DEVELOPMENT APPLICATION ASSESSMENT REPORT

Application Number:	DA2025/0525
----------------------------	-------------

Responsible Officer:	Tess Johansson
Land to be developed (Address):	Lot 26 DP 13291, 122 Hudson Parade CLAREVILLE NSW 2107
Proposed Development:	Construction of a carport
Zoning:	C4 Environmental Living
Development Permissible:	Yes
Existing Use Rights:	No
Consent Authority:	Northern Beaches Council
Land and Environment Court Action:	No
Applicant:	The Trustee For Progressive Plans Trust

Figure 1. Front setback non-compliance

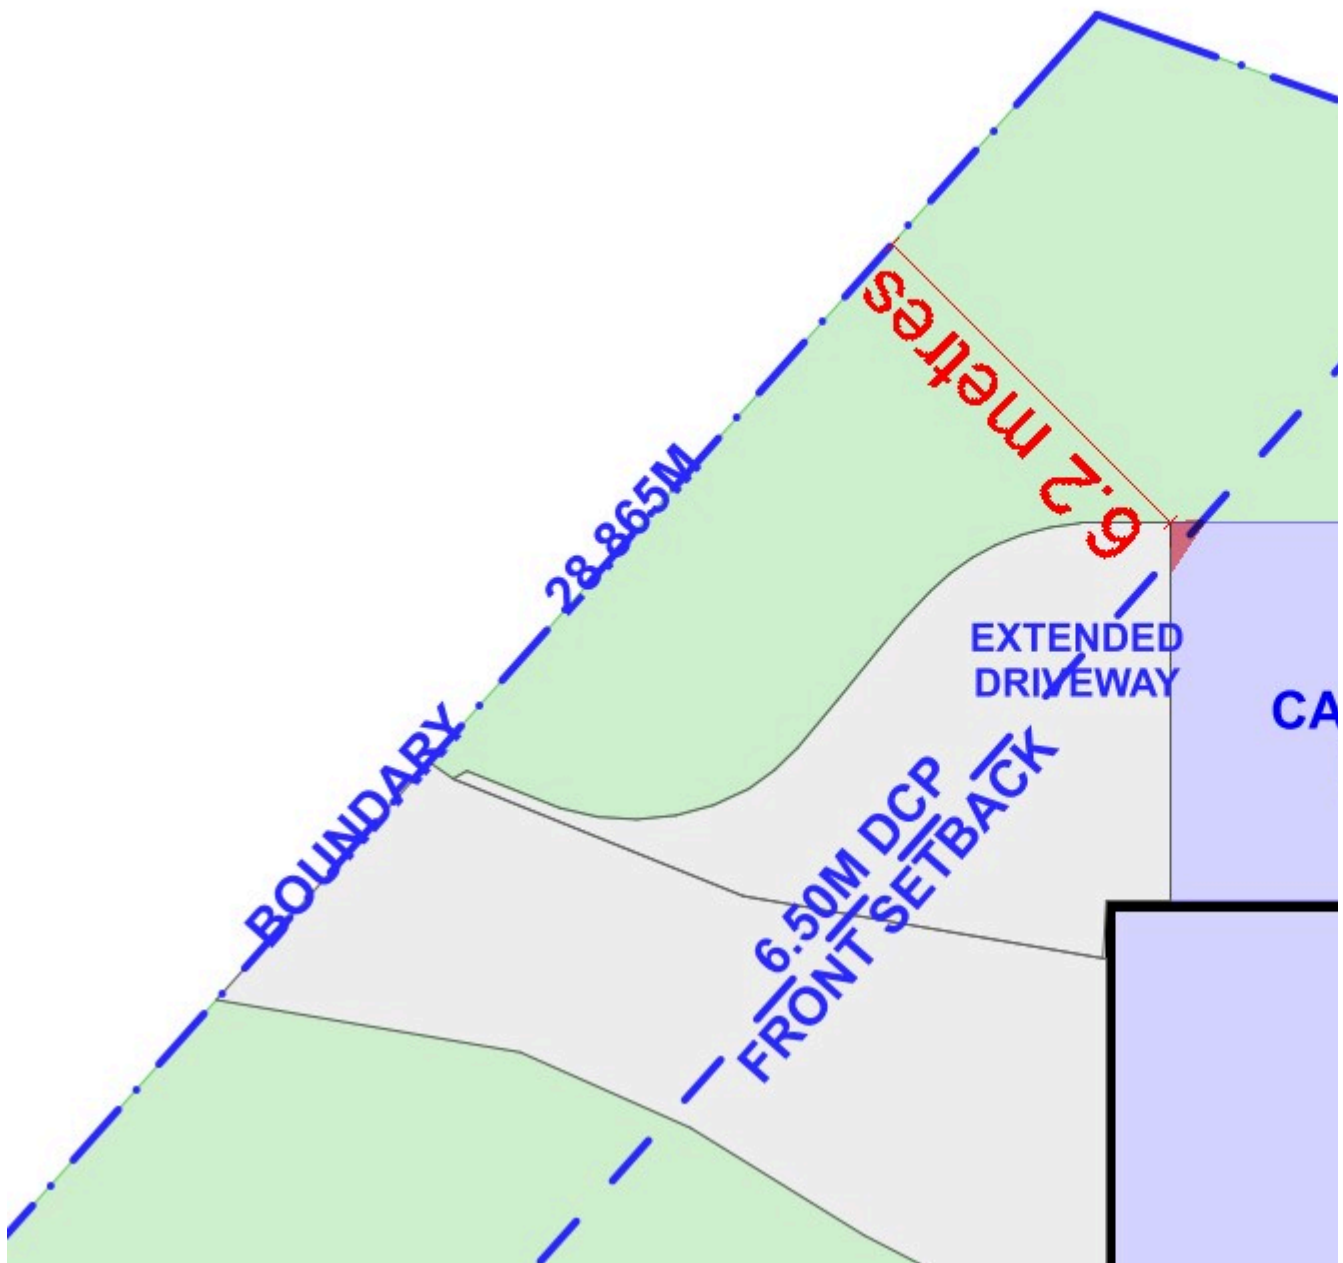
PDCP 21 part D1.8 requires a 6.5m front building line setback.

The front building line is taken from the north side, as access is provided from Delecta Avenue and the dwelling house fronts onto Delecta Avenue.

The proposed carport's north-eastern corner breaches the 6.5m setback, siting at 6.2m.

Having regard to the above assessment, it is concluded that the proposed development is consistent with the relevant objectives of PLEP 2014 / P21DCP and the objectives specified in s1.3 of the Environmental Planning and Assessment Act, 1979. Accordingly, this assessment finds that the proposal is supported, in this particular circumstance.
